DEVELOPMENT ASSESSMENT REPORT

<b>Application No.</b>	0102019000123.1
<b>Address</b>	4 Rosemount Avenue SUMMER HILL NSW 2130
<b>Proposal</b>	Alterations and additions to an existing dwelling
<b>Date of Lodgement</b>	21 August 2019
<b>Applicant</b>	Ms Janet E Angus
<b>Owner</b>	Janet Angus
<b>Number of Submissions</b>	Thirty one (31)
<b>Value of works</b>	\$1,200,000.00
<b>Reason for determination at Planning Panel</b>	Number of submissions exceeds 10
<b>Main Issues</b>	Heritage Conservation Area
<b>Recommendation</b>	Approval with conditions
<b>Attachment A</b>	Recommended conditions of consent
<b>Attachment B</b>	Plans of proposed development
<b>Attachment C</b>	Statement of Heritage Significance

10-01 D  
Landscape Concept Plan

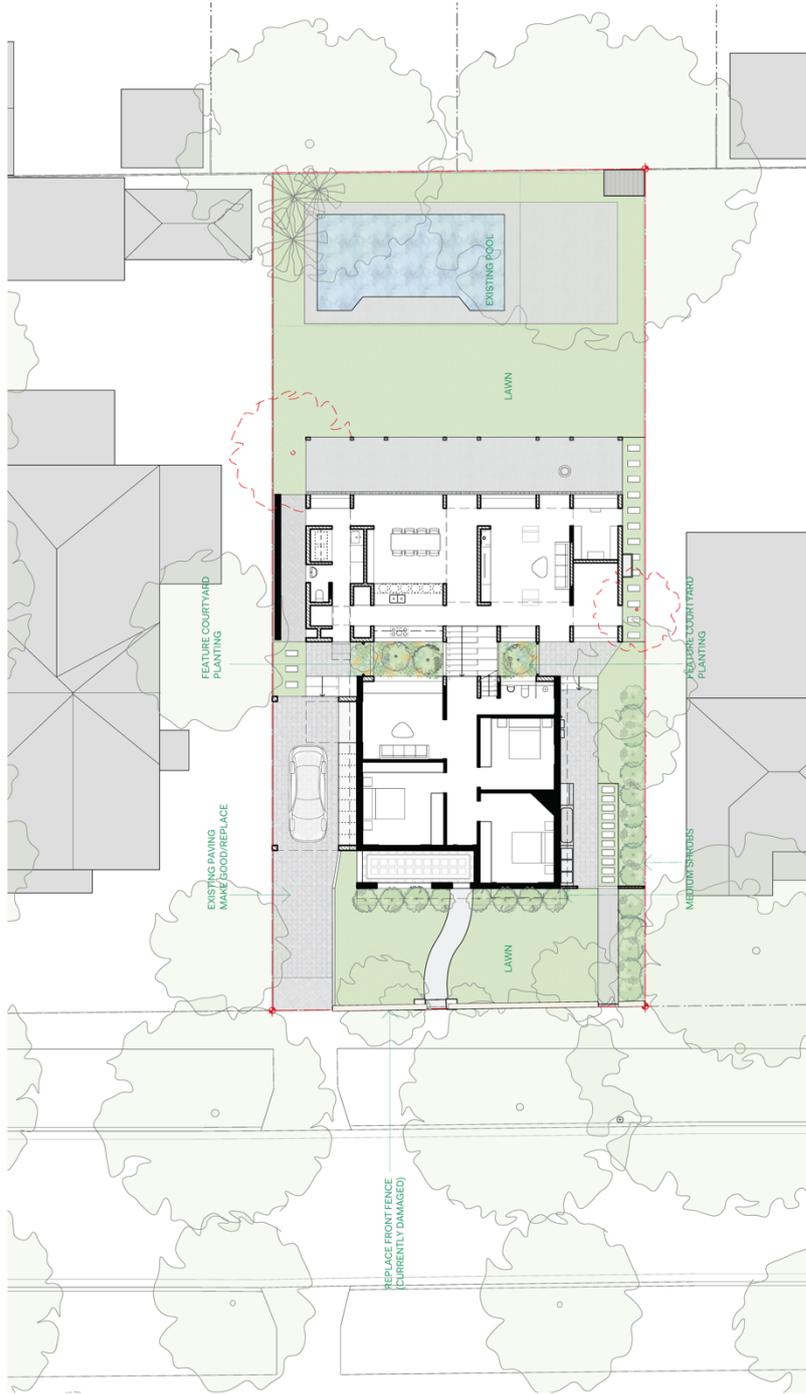
Comment: The proposal has been amended and is now compliant with the requirements of the DCP and rate of landscaped area. The proposal incorporates sufficient space on-site for the planting of new trees/ replacement trees. Appropriate conditions regarding tree planting are recommended for the consent.

Prior to the issue of a Construction Certificate, the Certifying Authority must be provided with an amended landscape plan certified, demonstrating compliance with the following:

- a) Location of all proposed and existing planting delineating existing trees to be retained, removed or transplanted.
- b) The location of two replacement canopy trees, each capable of achieving a mature height of at least six (6) metres.
- c) Details of drainage and watering systems.

17-01 E

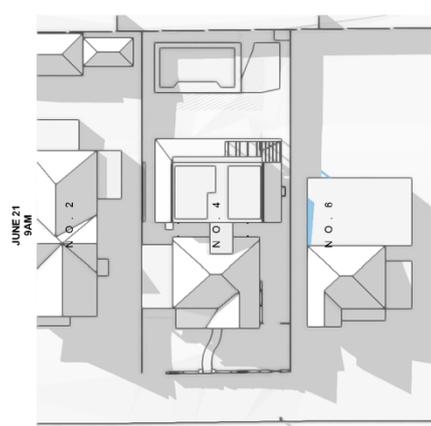
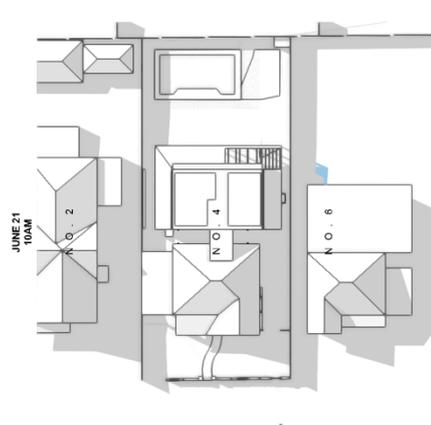
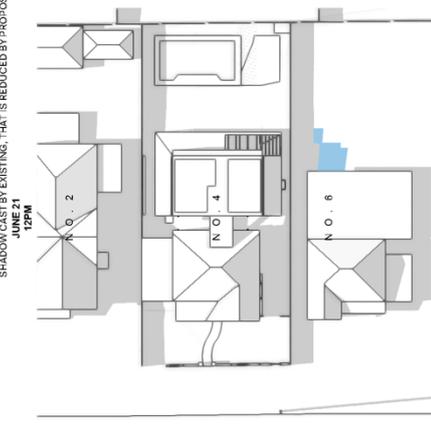
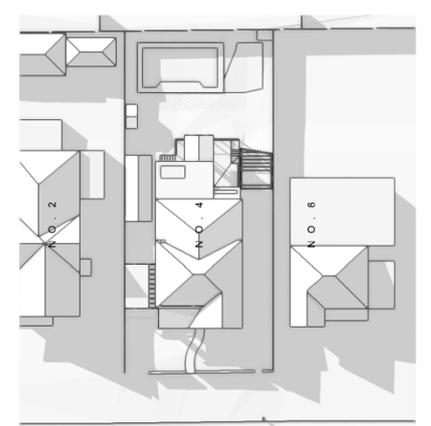
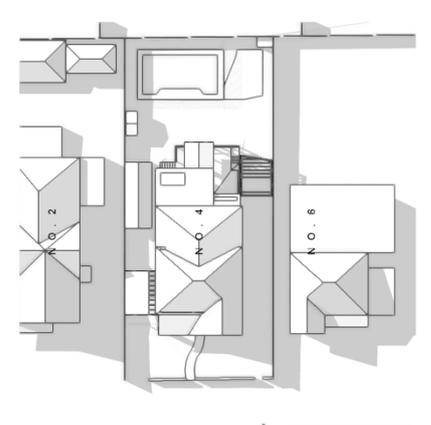
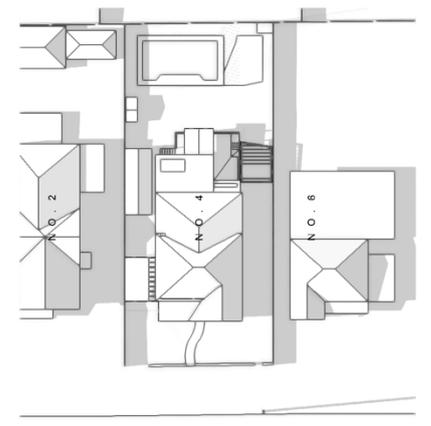
The proposal is generally compliant with Council controls, being compliant with height, FSR and setbacks. The proposal maintains a compliant rate of solar access to the POS of 6 Rosemount Avenue. The orientation of the lots is such that in order to retain existing levels of solar access to north facing windows a ban on any first floor additions would need to be imposed. Such an outcome is considered to be unreasonable and inconsistent with current planning controls.
